## ADDENDUM NO. 1

### CITY OF GROSSE POINTE WOODS

#### Hampton Rd Water Main & Resurfacing

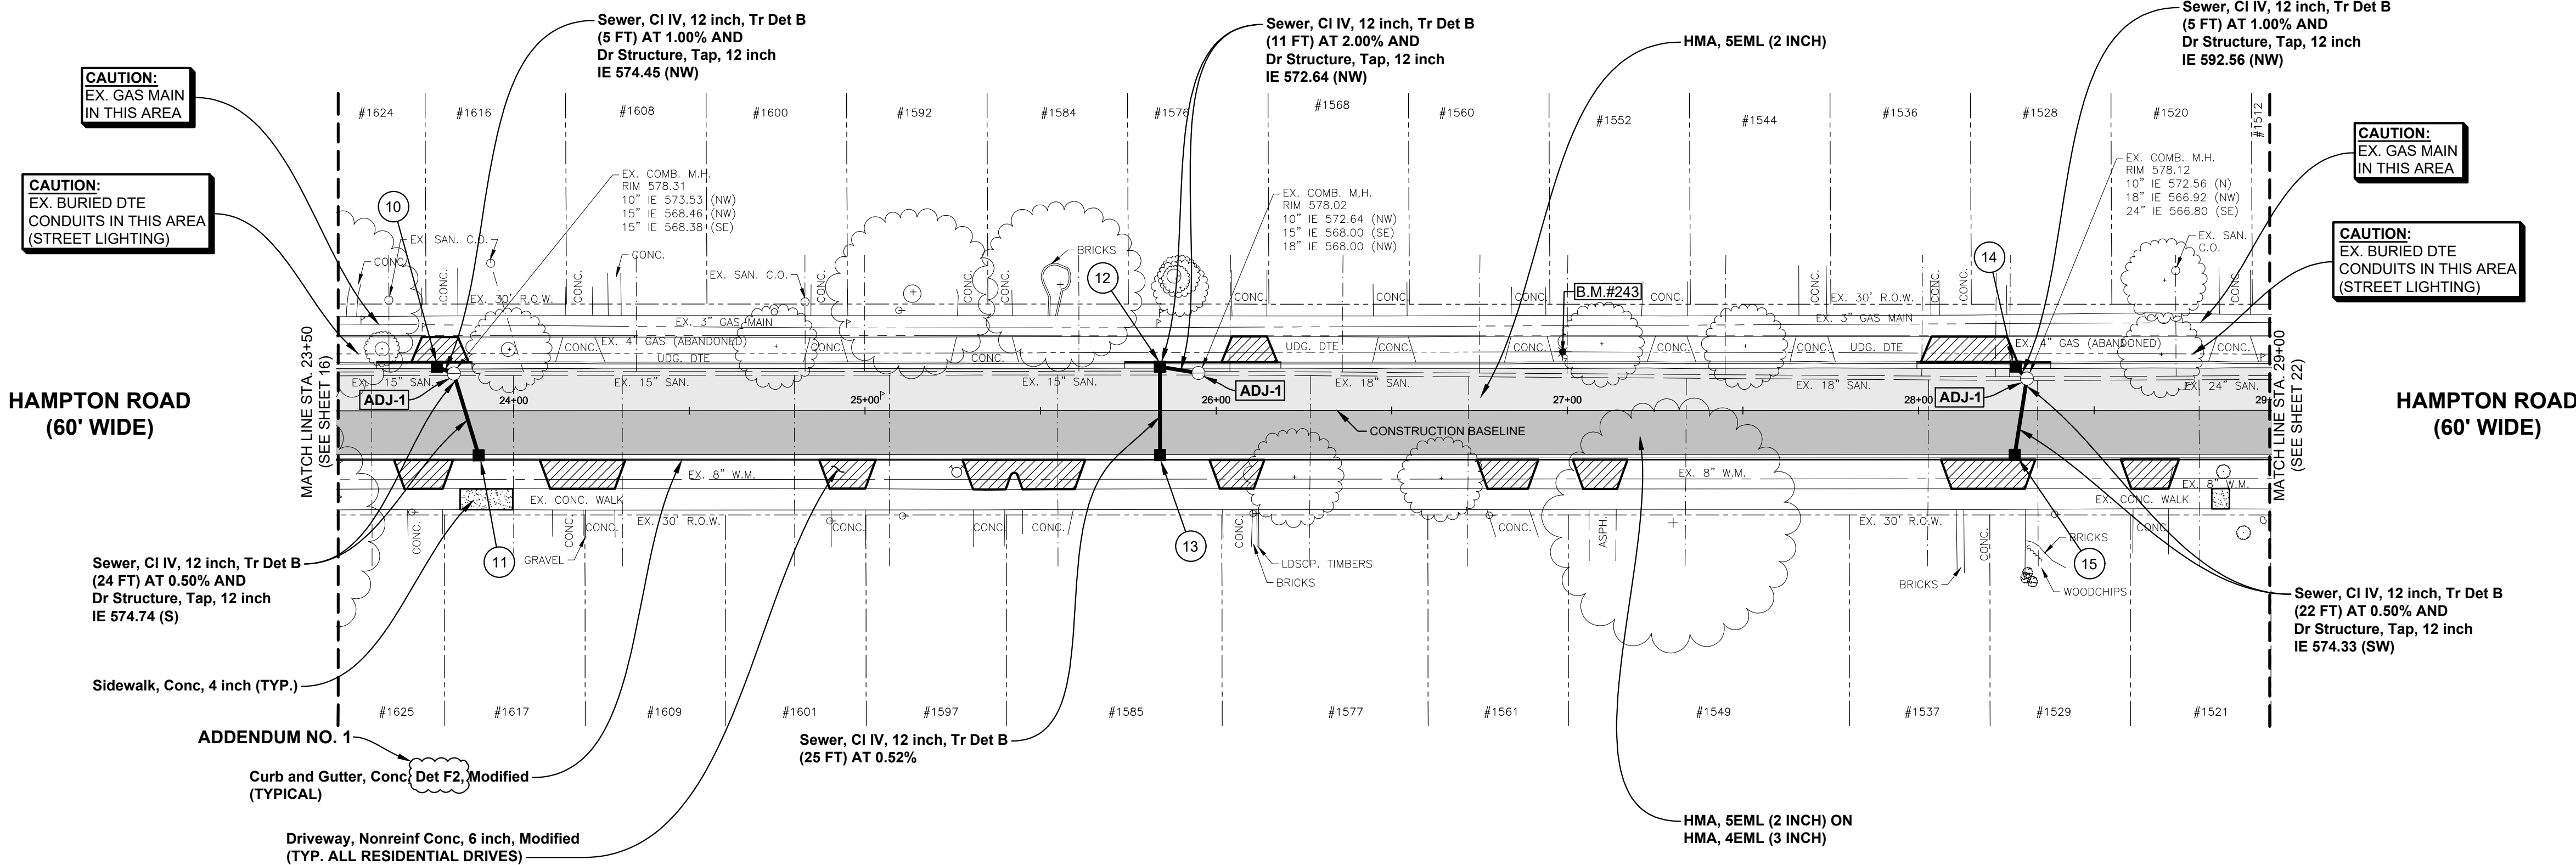
Sheets 9, 12, 13, 15, 16, 19, 21, 22, 25, and 27 have been revised to include minor corrections to annotations and plan quantities. The revised sheets have been attached to this addendum.

**ADDENDUM NO. 1**

**ADDENDUM NO. 1**

10 Dr Structure, 24 inch dia  
WITH 2' SUMP AND  
Dr Structure Trap, 12 inch AND  
External Structure Wrap, 18 inch AND  
Catch Basin Cover, Restricted, GPW  
STA. 23+78.13, 12.7' LT.  
RIM 577.98  
12" IE 574.50 (SE)

12 Dr Structure, 48 inch dia  
WITH 2' SUMP AND  
Dr Structure Trap, 12 inch AND  
External Structure Wrap, 18 inch AND  
Catch Basin Cover, Restricted, GPW  
STA. 25.84.00, 12.5' LT.  
RIM 577.84  
12" IE 572.86 (SE)  
12" IE 574.00 (S)

14 Dr Structure, 24 inch dia  
WITH 2' SUMP AND  
Dr Structure Trap, 12 inch AND  
External Structure Wrap, 18 inch AND  
Catch Basin Cover, Restricted, GPW  
STA. 25.84.00, 12.5' LT.  
RIM 577.90  
12" IE 572.61 (SE)
